Sundry ID: 2723494

Hilcorp Energy Company**Proposed P&A Procedure****Well: Hanks #4**

API: 30-045-06617

CONDITIONS OF APPROVAL

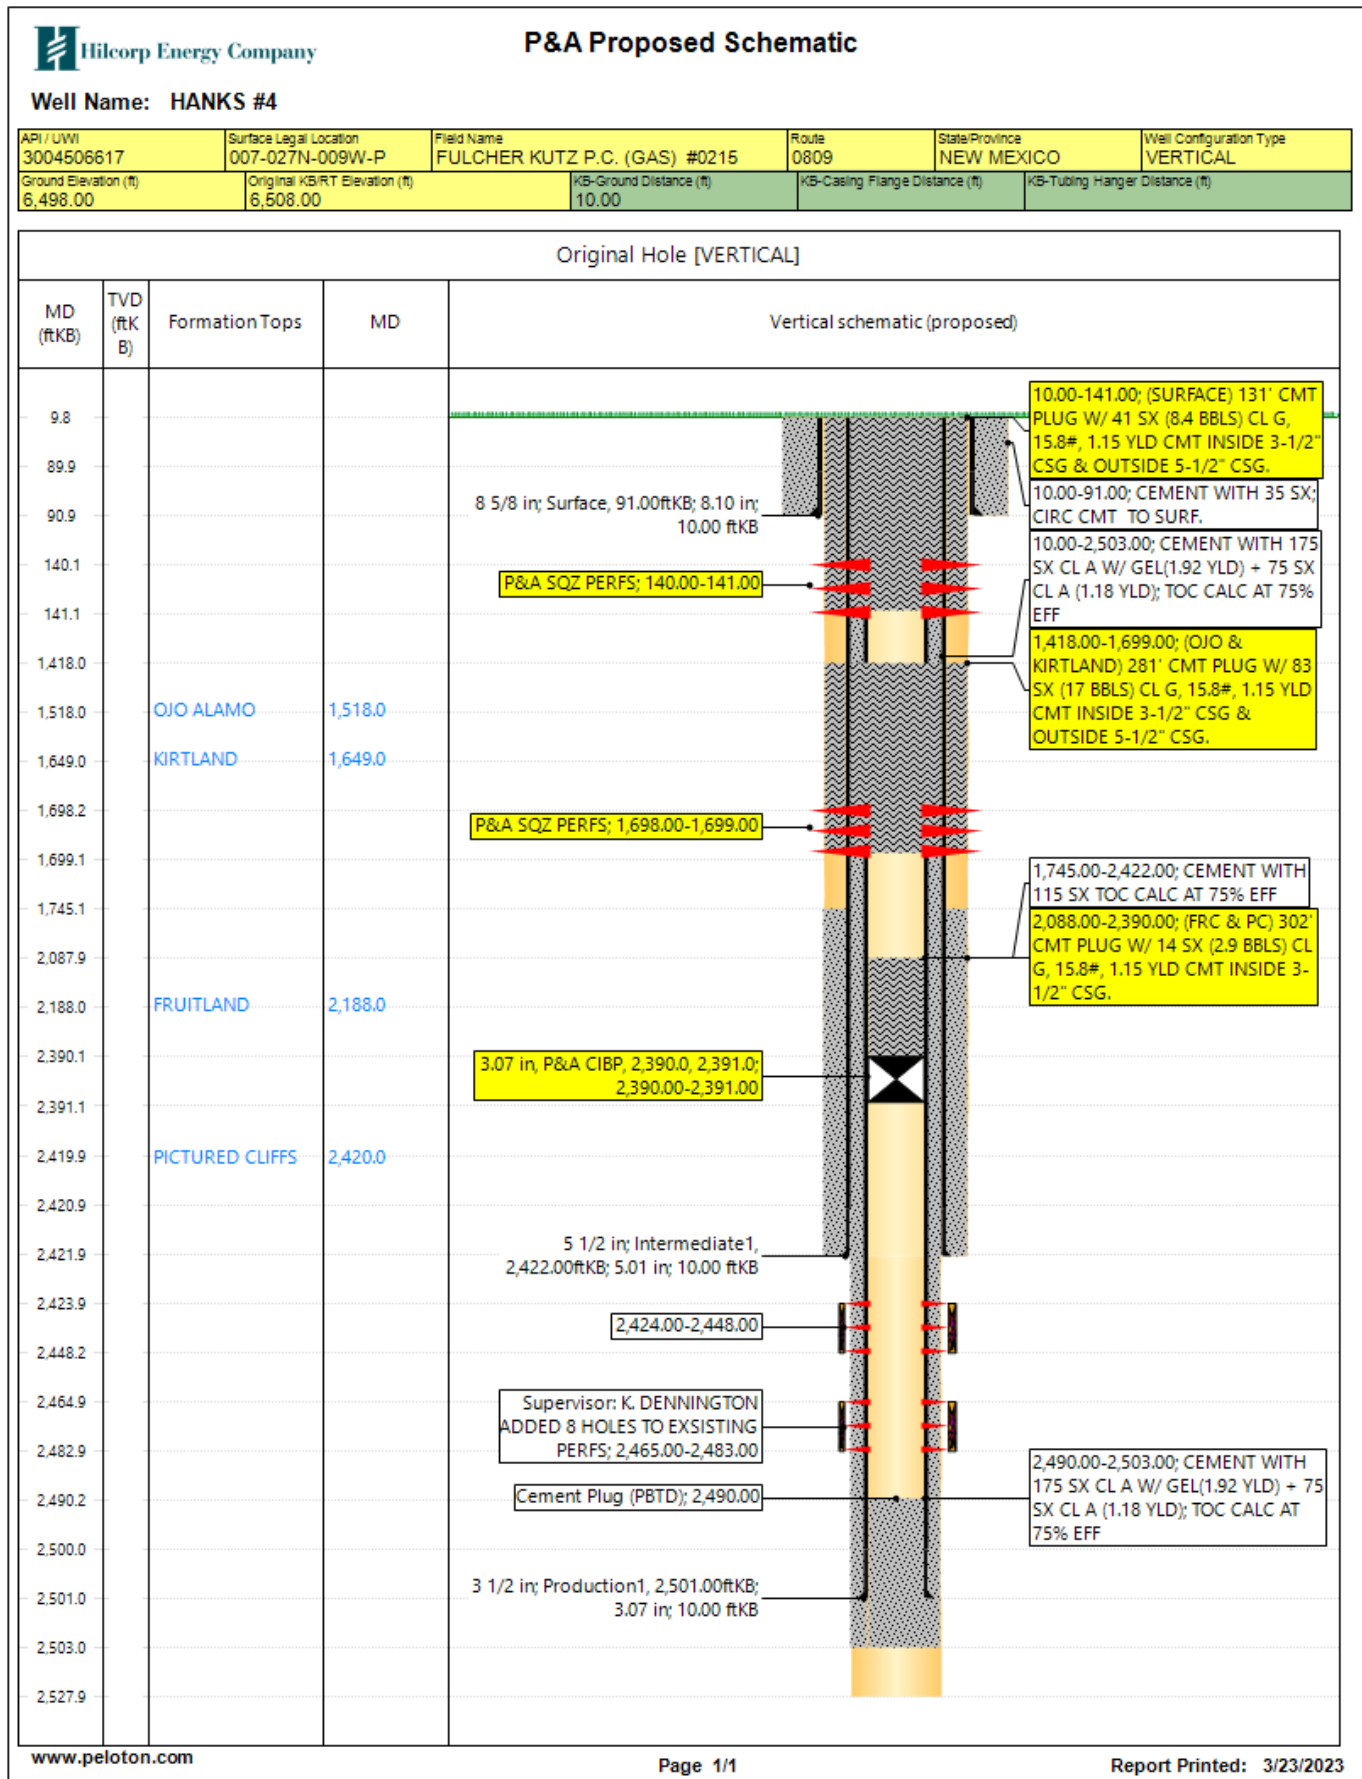
- Change the Plug 1 TOC to 2038' to account for the BLM Fruitland formation top.

1. Plugging operations authorized are subject to the attached "General Requirements for Permanent Abandonment of Wells on Federal and Indian Lease."
2. The following modifications to your plugging program are to be made:
 - a. Change the Plug 1 TOC to 2030' to account for the BLM Fruitland formation top.
3. Farmington Office is to be notified at least 24 hours before the plugging operations commence at (505) 564-7750.
